19 August 2019

Pearl High School Multipurpose Building

## ADDENDUM NO. 01

1 FIRST FLOOR PLAN  
1/8" = 1'-0"

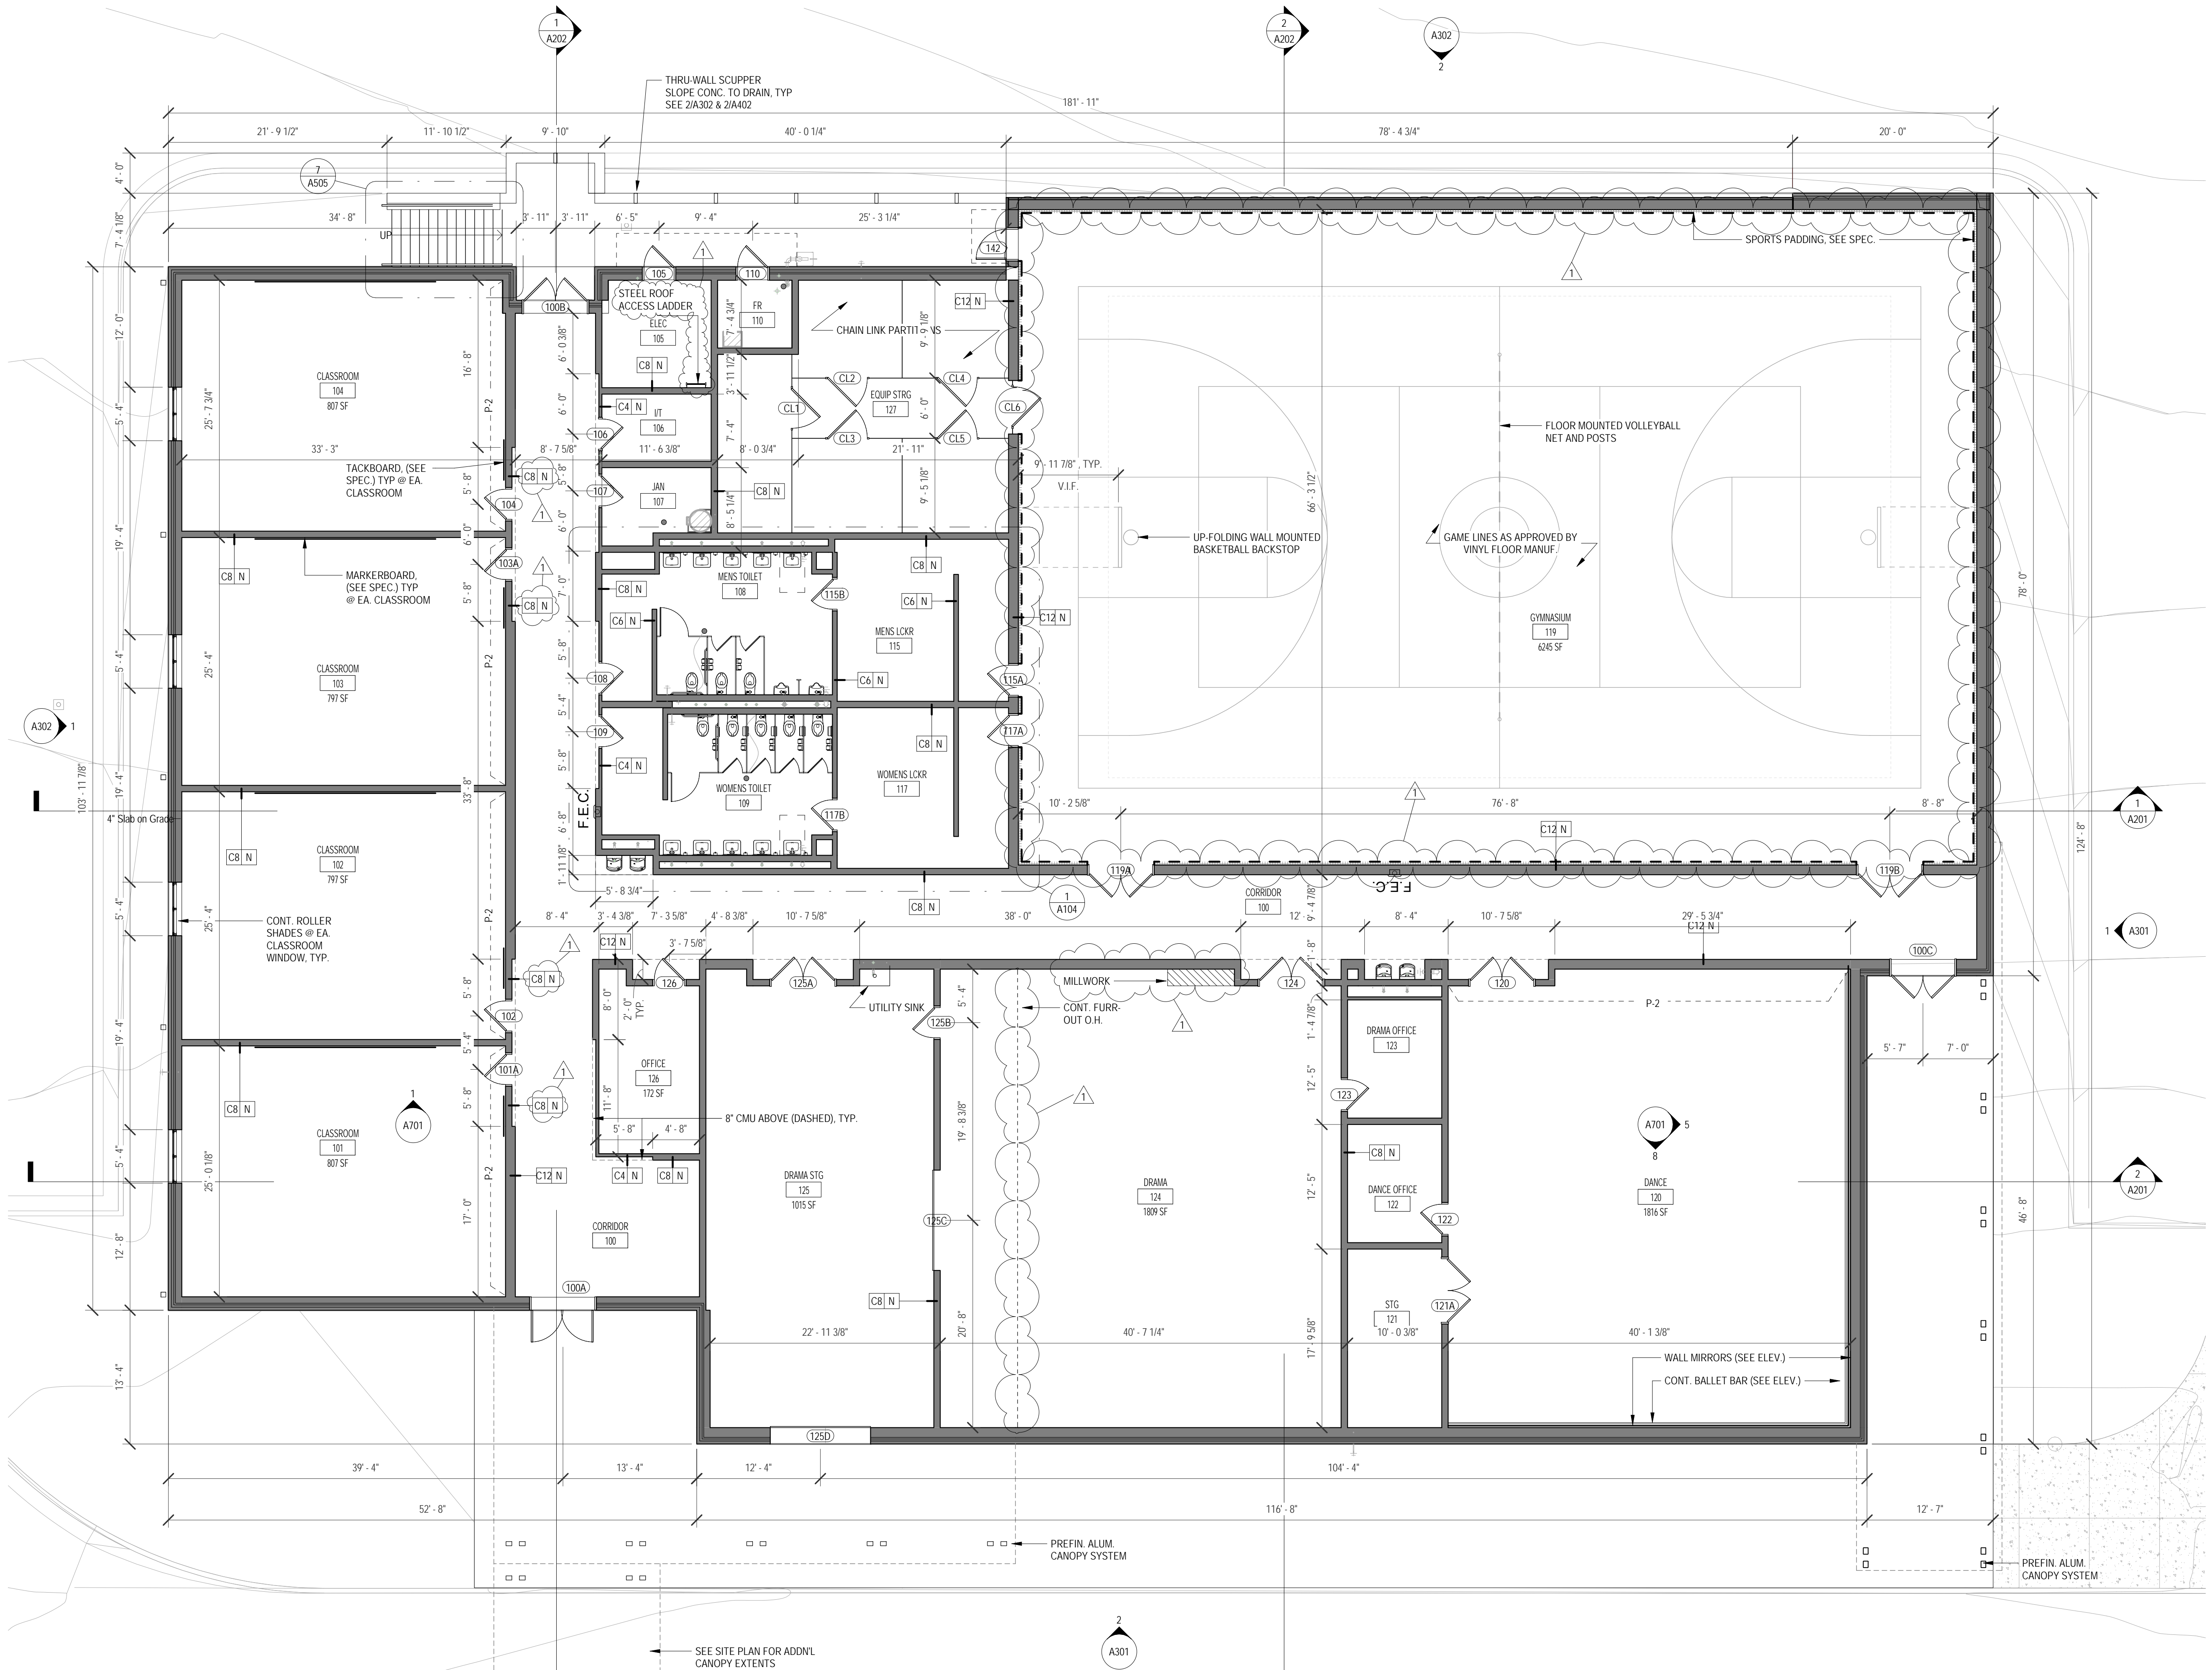
- ITEM NO. 39**      **SHEET C401 GENERAL CONSTRUCTION DETAILS**  
*REPLACE* sheet with attached revised sheet C401.  
*REVISES* Junction box detail.
- ITEM NO. 40**      **SHEET A101 FIRST FLOOR PLAN**  
*REPLACE* sheet with attached revised sheet A101.  
*Adds* roof access ladder in Elec 105.

1 ROOF PLAN  
3/32" = 1'-0"

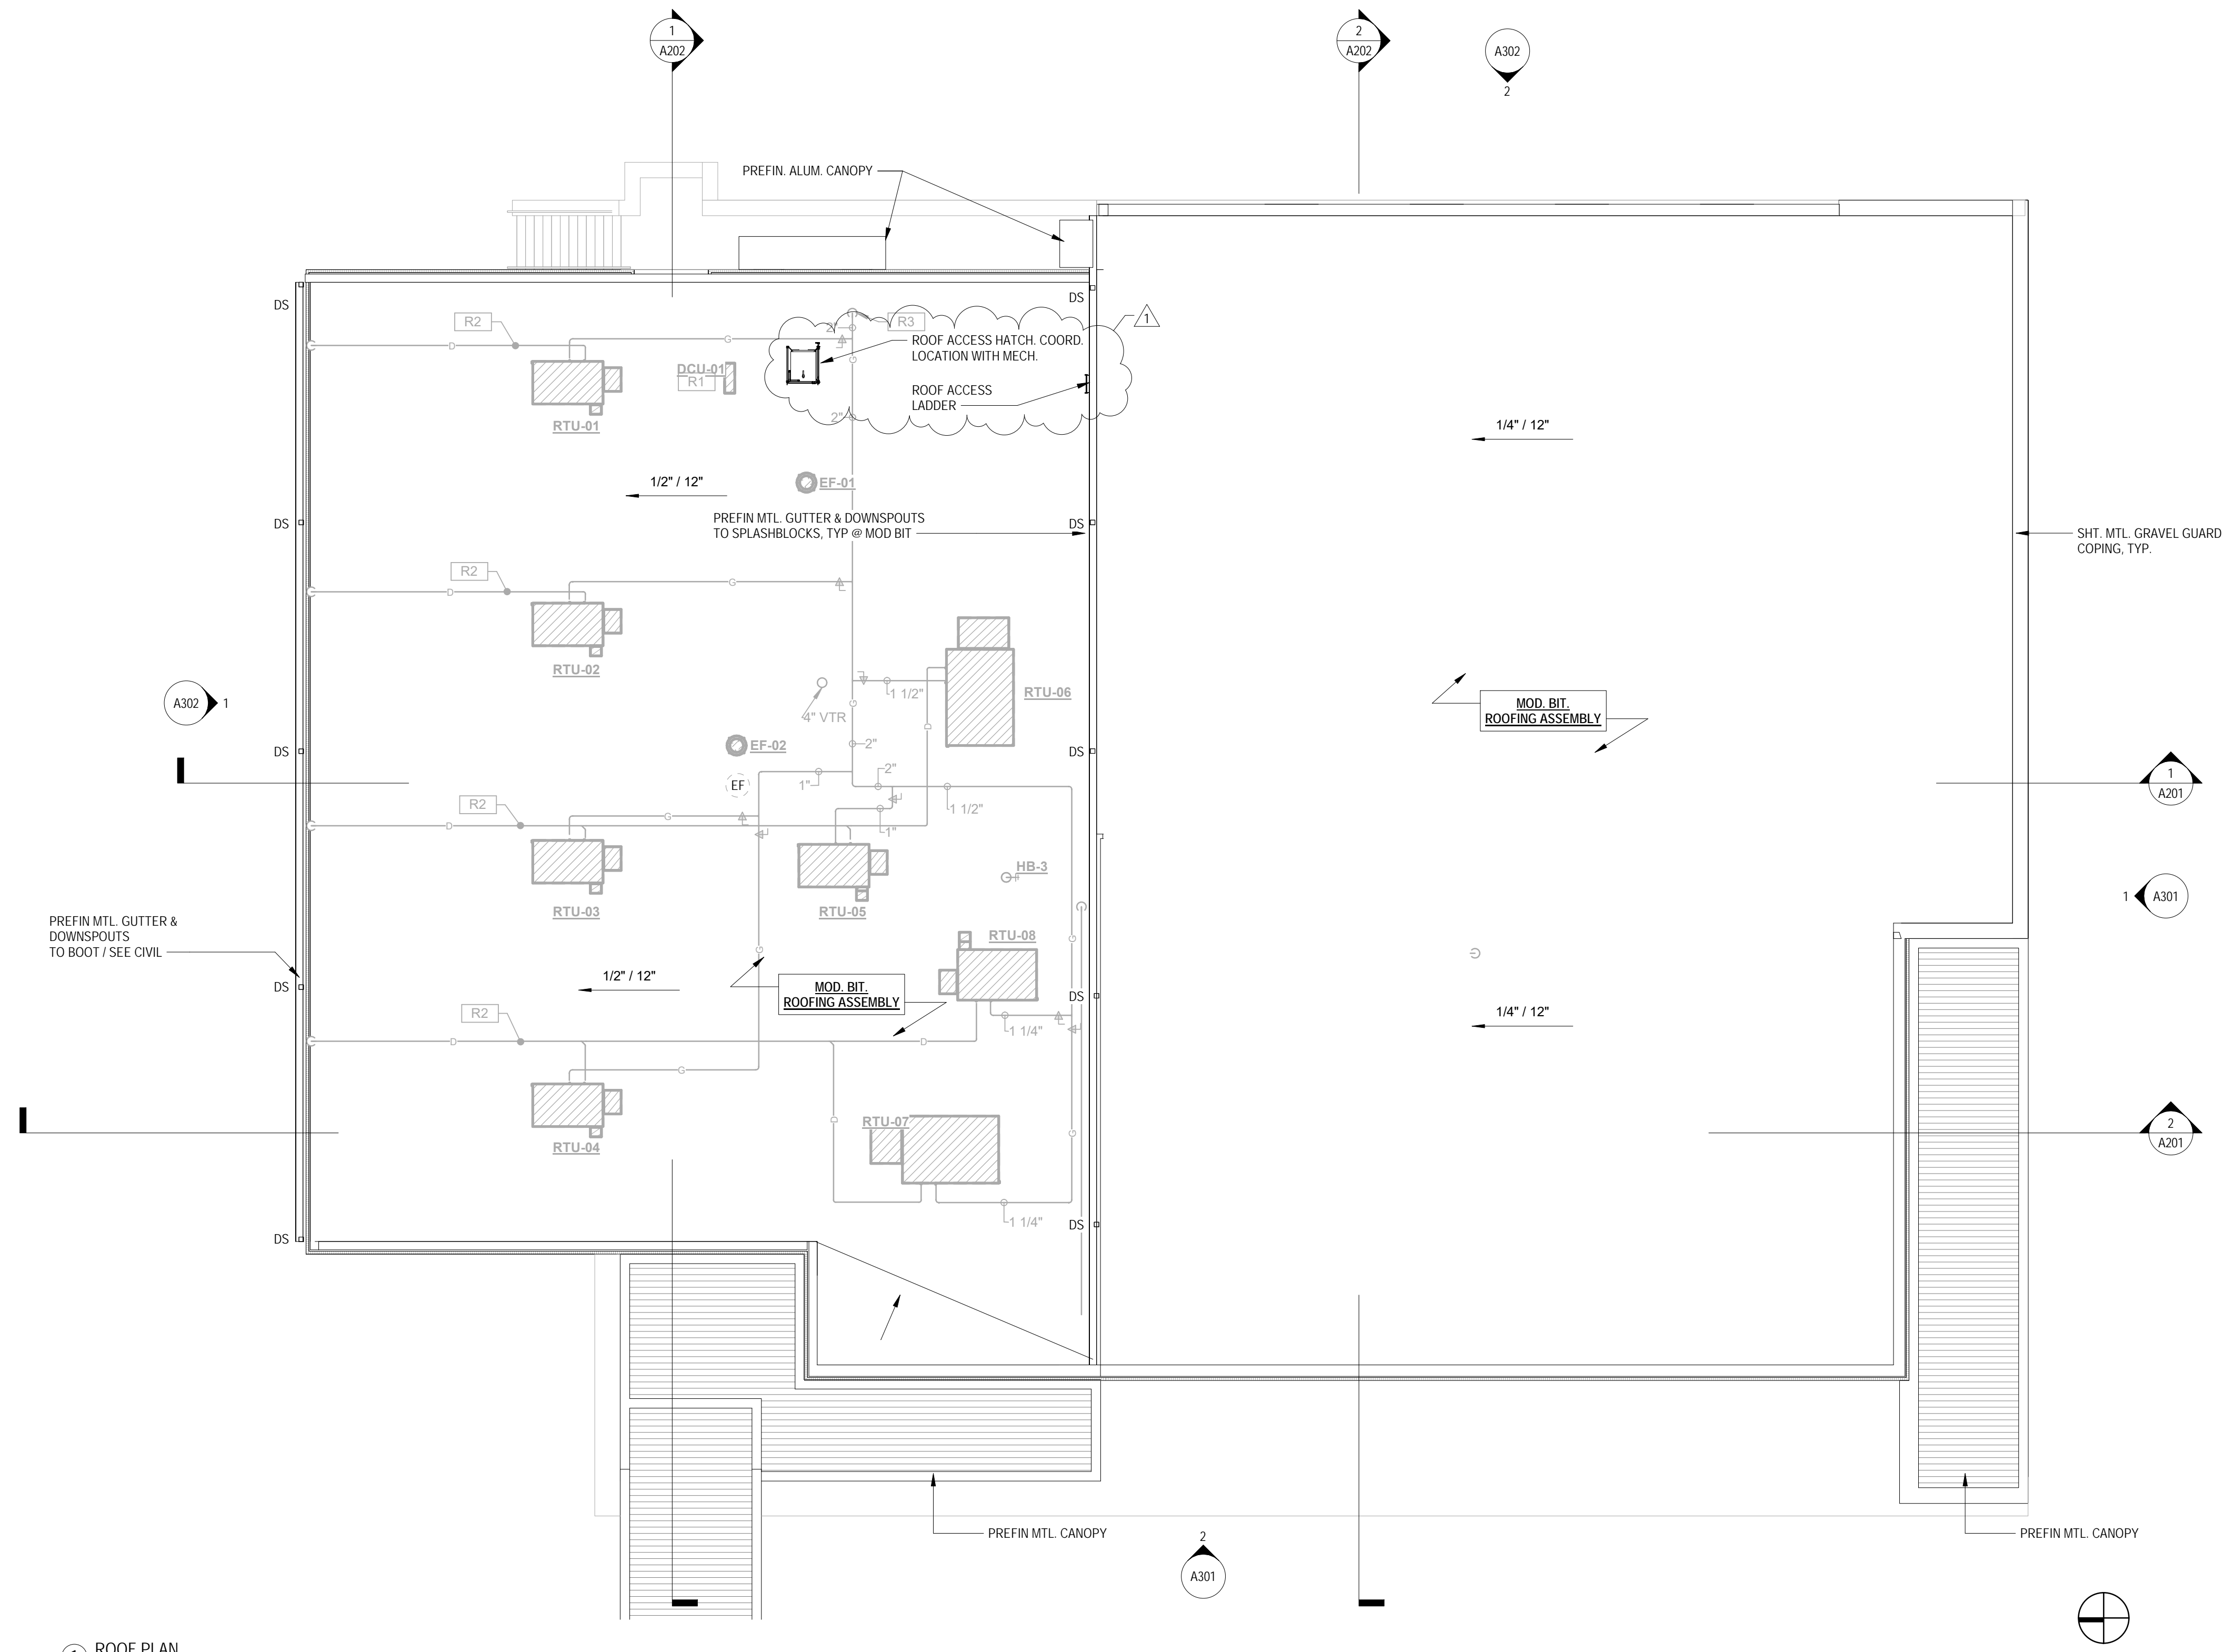
- ITEM NO. 41**      **SHEET A103 ROOF PLAN**  
*REPLACE* sheet with attached revised sheet A103.  
*Adds* detail of roof access ladder.
- ITEM NO. 42**      **SHEET A201 BUILDING SECTIONS**  
*REPLACE* sheet with attached revised sheet A201.  
*Adds* roof access ladder in Building Section A.

1 BUILDING SECTION C  
1/8" = 1'-0"

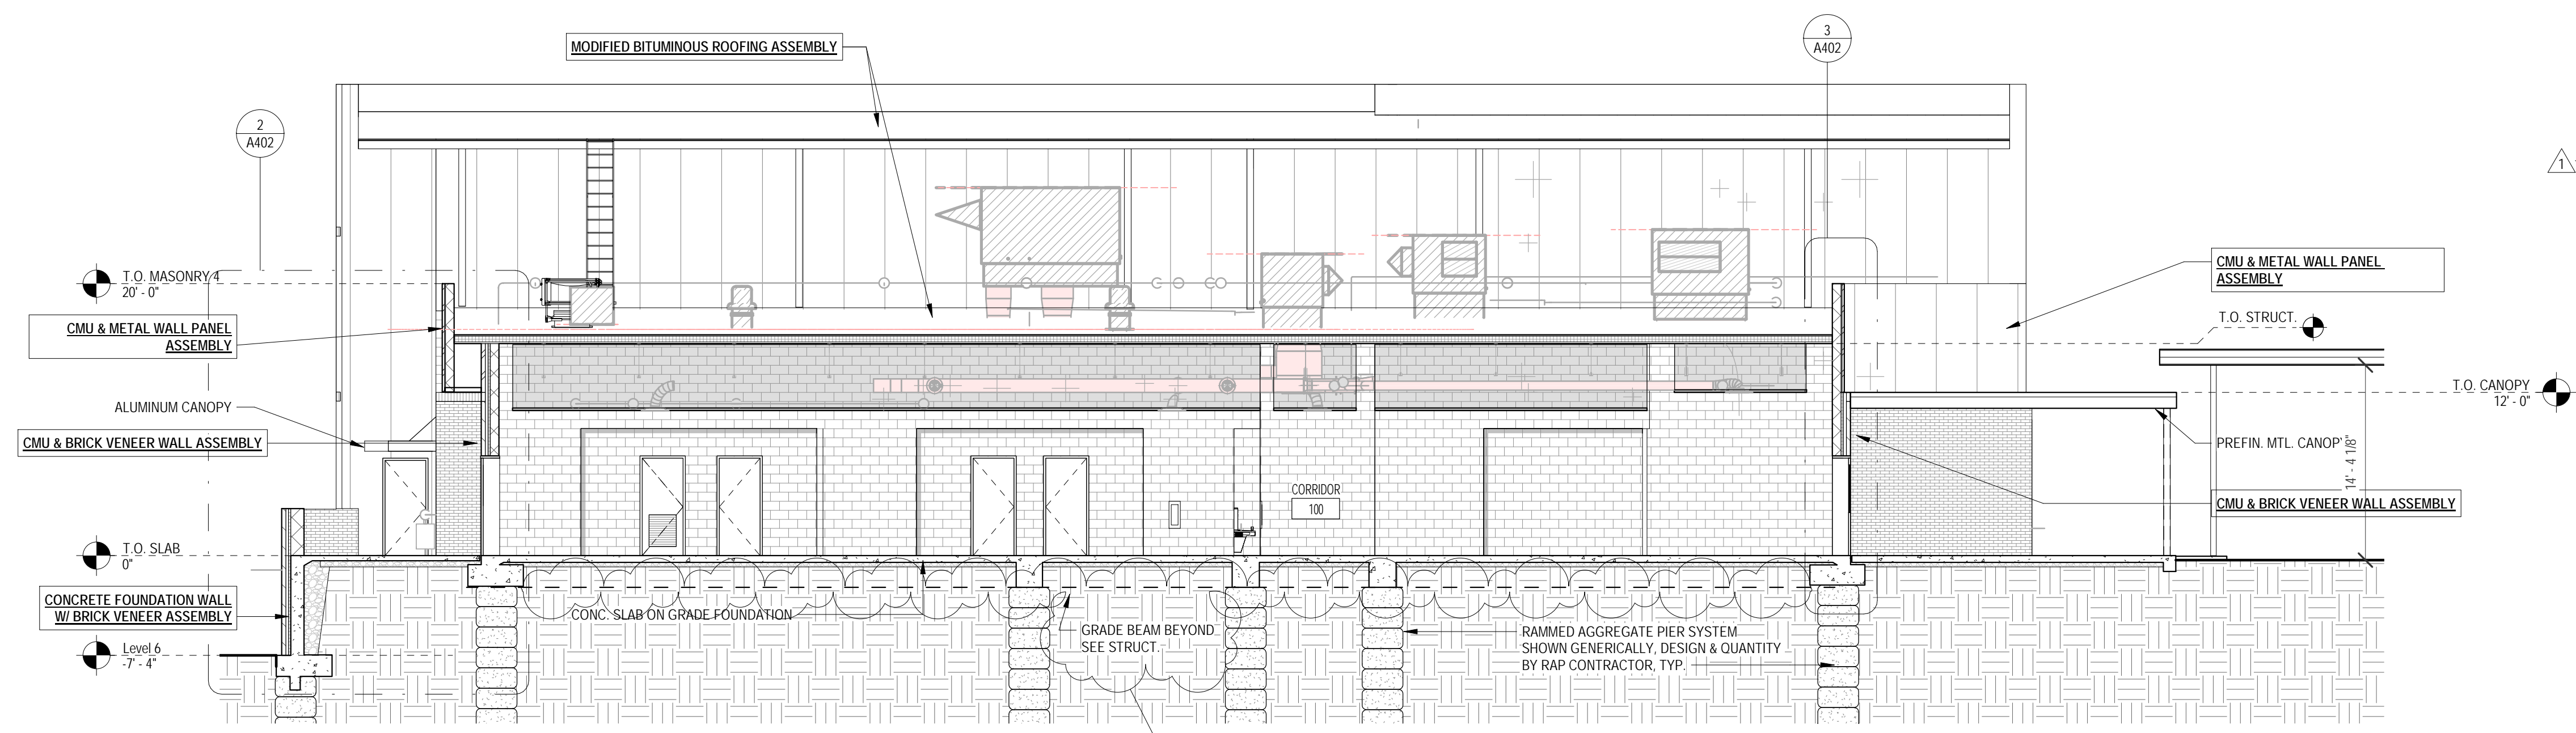
- ITEM NO. 43**      **SHEET A202 BUILDING SECTIONS**  
*REPLACE* sheet with attached revised sheet A202.  
*Adds* roof access ladder in Building Section A.
